SUMMARY OF CONCERNS IN RELATION TO THE PROPOSED NORTHCONNEX TUNNEL

This is an objection to many aspects of the proposed NorthConnex tunnel.

MOTORWAY OPERATIONS COMPLEX - SOUTHERN VENTILATION FACILITY - SECTIONS
M1-M2-5000-DR-JD-0525

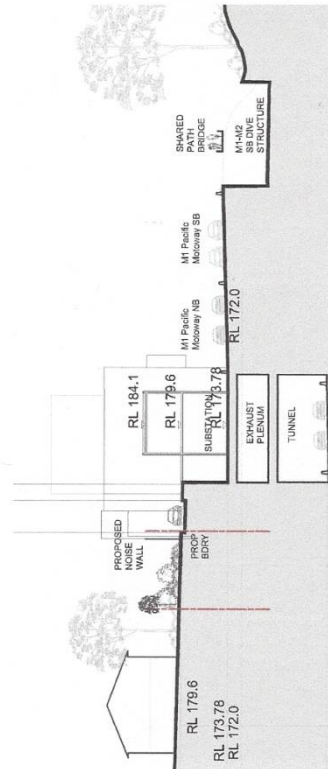
5. *EIS Volume 4, Technical working papers - Urban Design, 6.0 Operational Ancillary Facilities*
EIS Page 99 there is the diagram "Motorway Operations Complex – Southern Ventilation Facility – sections. *Page 10 below* The diagram has the cryptic label "Connection to tunnel TBC". What does TBC stand for? To be considered? Why is tunnel singular? Which tunnel is the diagram referring to northbound or southbound? There is no diagram showing any connection from the Southern Interchange ventilation facility to either the northbound or the southbound tunnel in any way AND YET

- Diagrams need to be provided showing the inter-relation between the shaft, the ventilation outlet and the motorway operations centre with a clear description of what is to be constructed and how it will operate.
- The community needs irrefutable evidence that the polluted air from the southbound tunnel exit portals will not be allowed to flow like an invisible sewer through West Pennant Hills, North Rocks, Carlingford and Beecroft.

M1-M2-5000-DR-UD-0550
NORTHERN VENTILATION FACILITY - CROSS SECTIONS

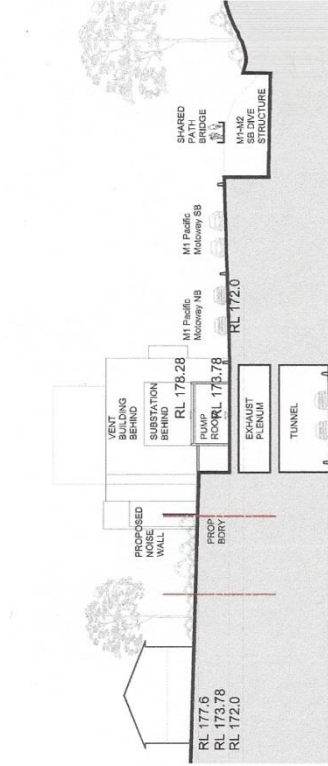
EIS page 135 *Page 11 below* there is a very explicit diagram showing the *Northern Ventilation Facility – cross section*.

Why are there no comparable diagrams for the Southern Interchange and the Southern Ventilation facility?

M1-M2-5000-DR-UD-0556
NORTHERN VENTILATION FACILITY - LONG SECTION

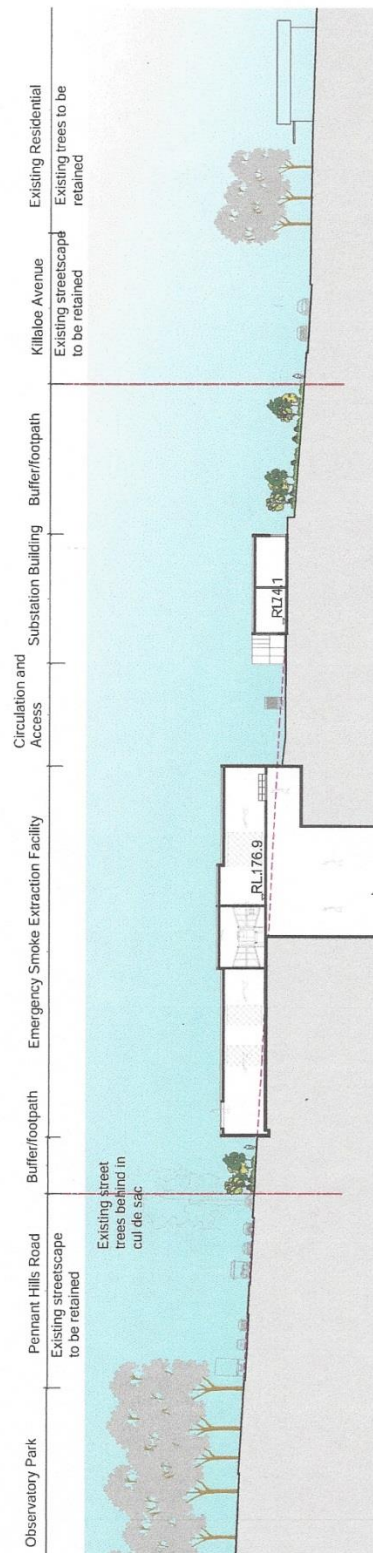
EIS page 134 *Page 12 below* there is a very explicit diagram showing the *Northern Ventilation Facility – long section*.
